schema 4: revisions to scheme 3

PROJECT
The Hoo: Scheme 3
 17 Lyndhurst Gardens,
 Hampstead, London
 Returning A Grand Victorian House To Private Domestic Accommodation
 NW3 5NU

DRAWING
Ground Floor Layout as Proposed

JOB No	DRAWING No	REVISION
19013	1121	L
STATUS	PLANNING

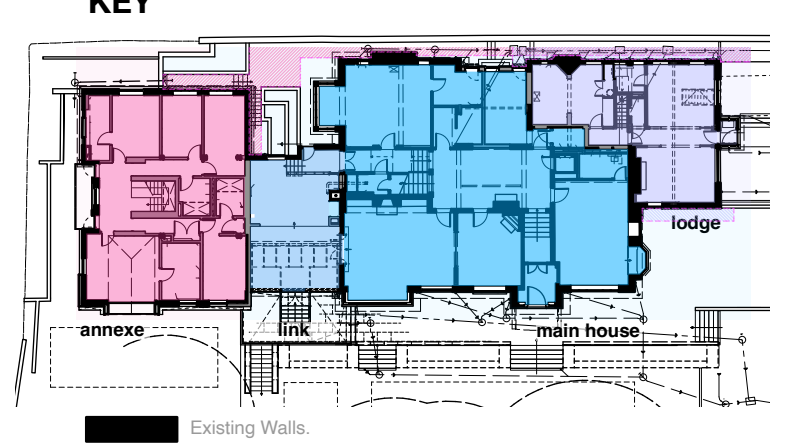
- 42 linc. proposals for contemporary new build link and associated landscape to front and rear are omitted. revised scheme is simplified and reduced. amended design utilises the volume and structure of the existing building and retains existing masonry loadbearing to the north and south. flat roof and structure are removed and replaced with new incorporating improved thermal performance. single glazed glass roof and south elevation are removed and replaced with new double glazing fitted to powder coated aluminium frames. new glazing in wide pane format allows an improved view of the garden from inside the office. revised proposals are naturally ventilated and more simply finished. linc. party wall with annex building is simplified and constructed in lightweight timber framing.

- 43 linc. upper terrace and external storage below reduced in size and simplified. external stair providing access to lower ground floor is named and existing structure is adapted to return to existing levels.

- 44 linc. external stair accessing link building is reduced in width and simplified.
- 45 main house: opening of former aperture into the link is returned to its original width to avoid clashing with existing services.

- 47 main house: ventilating ductwork to wc M0.07 is routed through the existing link roof structure to terminate out of site when viewed from window M1.016 (above).

- 48 main house: existing bay window, which was proposed for demolition in the previously approved scheme to accommodate the contemporary link, is returned to the application proposals external staircase leading to ground level of annex simplified and returned through 90 degrees.

- 49 annex: entire existing floor at ground level is removed and replaced with an open web structure to allow effective servicing of the building.
- 50 annex: additional demolition of internal walls. all internal walls are removed as a consequence of the removal of the floor at ground level.

- 51 annex: structural engineers structure is included.
- 52 main house: existing window, previously modified with modern double glazed powdercoated aluminium frames, is adapted to facilitate access in the event of fire, a requirement of the fire regulations. modern central panel is removed and replaced with a pair of opening metal casements using M3.W05 as a template, which is assumed to be the original arrangement of the original historic window. single glazed with leaded lights, all details to closely match M3.W05 adjacent.
